UNITED STATES
NUCLEAR REGULATORY COMMISSION
WASHINGTON, D. C. 20555

MEMORANDUM FOR: Vincent S. Noonan, Director
Comanche Peak Project

SUBJECT: FEEDBACK INTERVIEW OF WITNESS A-44

CMC 7401 Rev 2

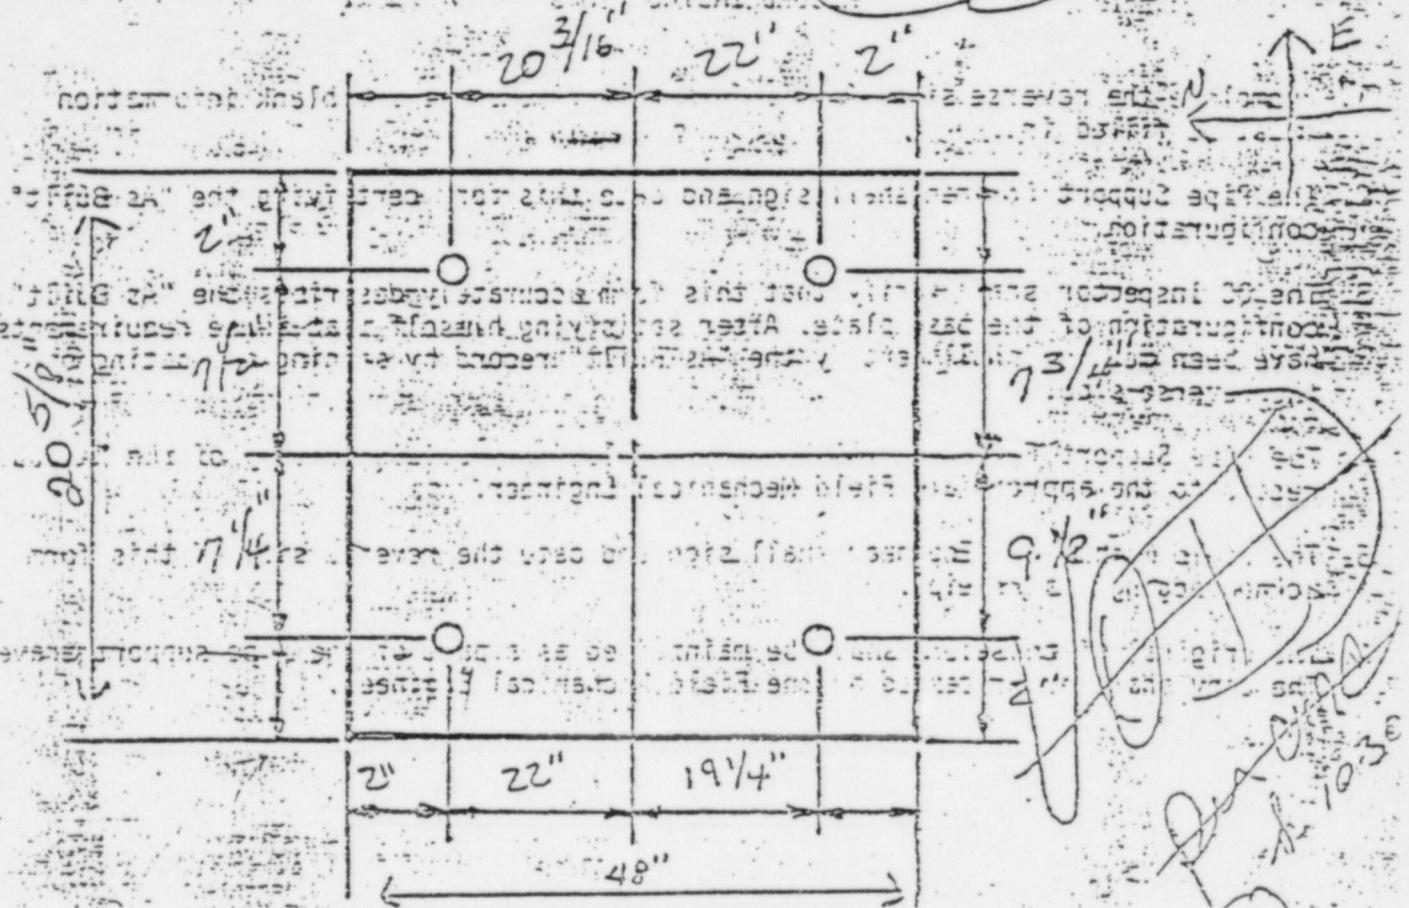
REASON FOR CHANGE: *INTERFERED WITH PIPE AND HILL GUS, HILL BOLTS CANNOT BE INSTALLED ON EXISTING UNDER 24" PIPE.*

ADDED WELD NUTS AND REVERSED BASE PL.
